Elizabeth Bettenhausen's comments  
**re: Initial Study of Environmental Impact (ISEI) of  
 Geotechnical and Hydrogeologic Study at Santa Rosa Creek Beach  
 and the draft Negative Declaration  
 proposed by the Cambria Community Services District**

The federal lead agency of the proposed geotechnical and hydro-geologic study is the Army Corps of Engineers. The local lead agency of the same study is the Cambria Community Services District. The proposed study is described in the Coastal Consistency Determination (CCD) the Army Corps of Engineers sent to the California Coastal Commission in December 2009. The Initial Study was composed between January 5 and 13, 2009.

# FEMA-FIRM FLOOD HAZARD MAP

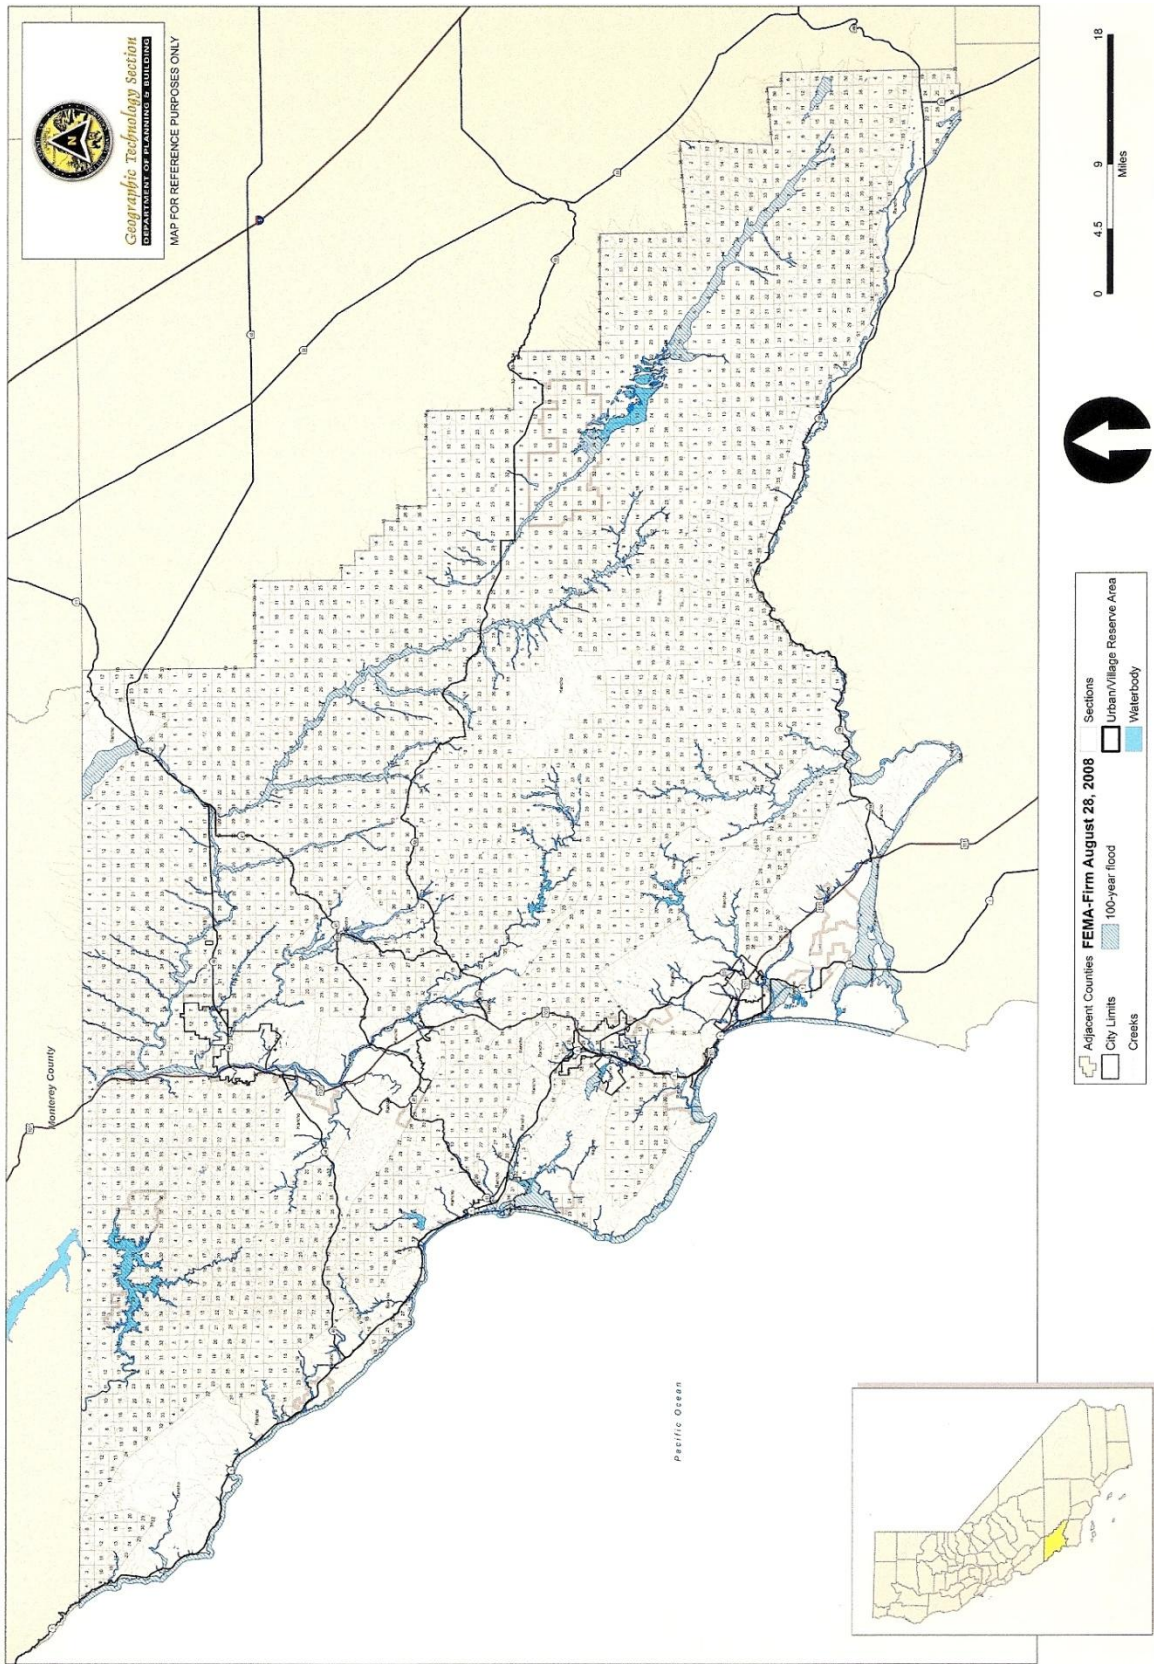
Third, the threat of flood is also discounted, again without reasons. However, the entire coast of Cambria is in a 100-year flood zone. Certainly structures in the beach, i.e., the three test wells and six monitoring wells are subject to “the flood elevation that has a 1- percent chance of being equaled or exceeded each year.”
